Access Compliance Report

Public Rights-of-Way

| Intersection ID: 32283 | Main Street: MYERS_MILL_LN | Cross Street: LANDING_PLACE_LN | Location: NE |
| ADA ID: E3BDBD13A550 | Ramp Type: PerpDiag | Initial Pass/Fail: Fail | Overall Compliance: No |

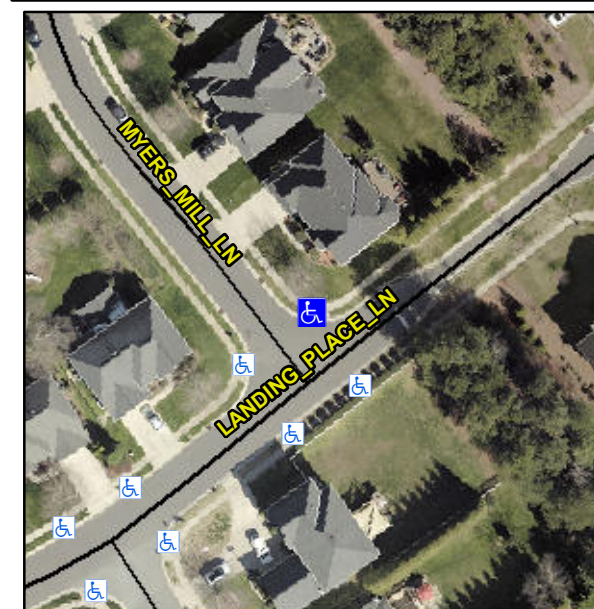
Not Found, R304.5.1, R304.2.2, R304.5.3

| Compliance | Description | Data | Compliance | Description | Data |
|------------|-----------------------|-------|------------|-----------------------------|-------|
| N/A | Ramp Length (in) | 46.0 | No | Ramp Slope (%) | 8.4 |
| No | Ramp Width (in) | 47.0 | No | Ramp XSlope (%) | 3.5 |

Remove & Replace Curb Ramp With Two New Directional Ramps or Equivalent.
